Work Order ID 101168

Item Name: Crosstube Turning Detail

DART AEROSPACE LTD HAWKESBURY, ONTARIO, CANADA	
DRAWING NO. D407-667-145	REV. C SHEET 1 OF 4
TITLE CROSSTUBE ASS'Y (407 HIGH FWD)	SCALE NTS
COPYRIGHT © 2002 BY DART AEROSPACE LTD <small>THIS DOCUMENT IS PRIVATE AND CONFIDENTIAL AND IS SUPPLIED ON THE EXPRESS CONDITION THAT IT IS NOT TO BE USED FOR ANY PURPOSE OR COPIED OR REPRODUCED TO ANY OTHER PERSON WITHOUT WRITTEN PERMISSION FROM DART AEROSPACE LTD.</small>

DRAWING NO. D407-667-145	TITLE CROSSTUBE ASS'Y (407 HIGH FWD)	REV. C	DART AEROSPACE LTD ENGINEERING ORDER		D.E.O. NO. D407-667-145-C-1	SHEET NO. SHEET 1 OF 1	SCALE NTS
DRAWN 97	CHECKED ASS	MFG. APPR. IB	APPROVED MD		DE APPR. H		
DATE 11.07.15	DATE 11.07.22	DATE 11.07.22	DATE 11/07/22		DATE 11.07.21

DETAIL P
BONDING STRAP INSTALLATION 2 PL

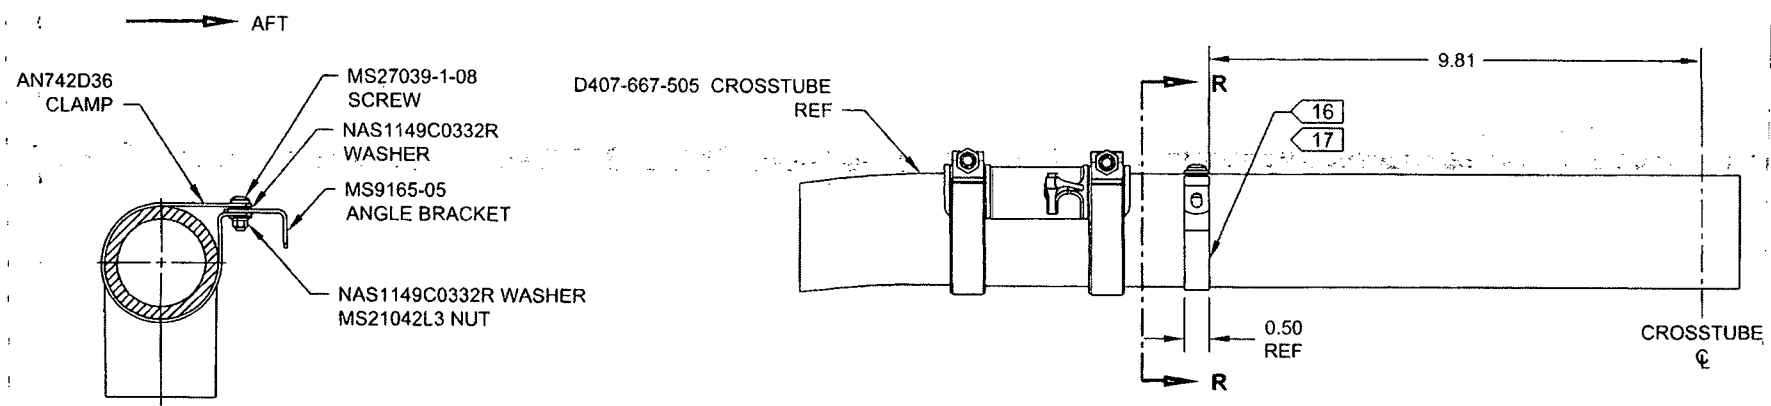
PURPOSE:

ADD ELECTRICAL GROUNDING STRAP

ITEM	QTY -145	PART NUMBER	DESCRIPTION
1	X	D407-667-145	CROSSTUBE ASSEMBLY (407 HIGH FWD)
10	2	AN742D36	CLAMP
11	2	MS9165-05	ANGLE BRACKET
12	2	MS21042L3	NUT (OR MS21042-3)
13	2	MS27039-1-08	SCREW
14	4	NAS1149C0332R	WASHER (OR AN960C10L)

- 16) MASK AREA UNDER CLAMP PRIOR TO PAINTING
- 17) SEAL EDGES WHERE AN742D36 CLAMP MEETS WITH THE CROSSTUBE USING SIKAFLEX-241/-291 OR MIL-S-8802 CLASS B2 OR PROSEAL 890 SEALANT
- 18) PERFORM RESISTANCE CHECK TO ENSURE MAX RESISTANCE IS 10 MILLIOHMS
